Access Compliance Report

Public Rights-of-Way

Intersection ID: 17018	Main Street: HANSON_DR	Cross Street: PROVIDENCE_RD	Location: SW
ADA ID: 6934BFA66908	Ramp Type: PerpDiag	Initial Pass/Fail: Fail	Overall Compliance: No
Severity Score: 17.5			
Codes/Mitigation Info/Possible Solution		Field Measurements/Component Compliance

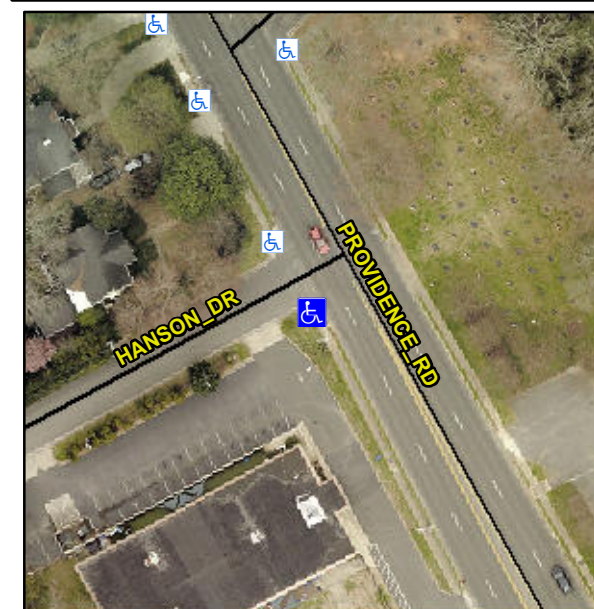
Not Found, R304.5.1

Compliance	Description	Data	Compliance	Description	Data
N/A	Ramp Length (in)	60.0	Yes	Ramp Slope (%)	5.8
No	Ramp Width (in)	34.0	Yes	Ramp XSlope (%)	1.4
N/A	Flare Type LT	N/A	N/A	Flare Type RT	N/A
N/A	Flare Slope LT (%)	N/A	N/A	Flare Slope RT (%)	N/A
N/A	Flare Traversable LT?	N/A	N/A	Flare Traversable RT?	N/A
N/A	Landing Length (in)	N/A	N/A	DWS Provided?	N/A
N/A	Landing Width (in)	N/A	N/A	DWS Contrast?	N/A
N/A	Landing Slope (%)	N/A	N/A	DWS Length (in)	N/A
N/A	Landing X Slope (%)	N/A	N/A	DWS Full Width?	N/A
N/A	Landing Curb? (Y/N)	N/A	N/A	DWS Offset (in)	N/A
N/A	Shared Landing?	N/A			
N/A	Gutter Ponding?	N/A	N/A	Gutter Slope (%)	N/A
N/A	Gutter Lip Ht (in)	N/A	N/A	Gutter X Slope (%)	N/A
N/A	Painted X Walk1?	No	N/A	Painted X Walk2?	No
	X Walk 1 Direction	To NE		X Walk 2 Direction	To NW
N/A	X Walk 1 Width (in)	N/A	N/A	X Walk 2 Width (in)	N/A
	X Walk 1 Slope (%)	9.3		X Walk 2 Slope (%)	5.2
	X Walk 1 X Slope (%)	0.9		X Walk 2 X Slope (%)	3.9

Remove & Replace Curb Ramp With Two New Directional Ramps or Equivalent.
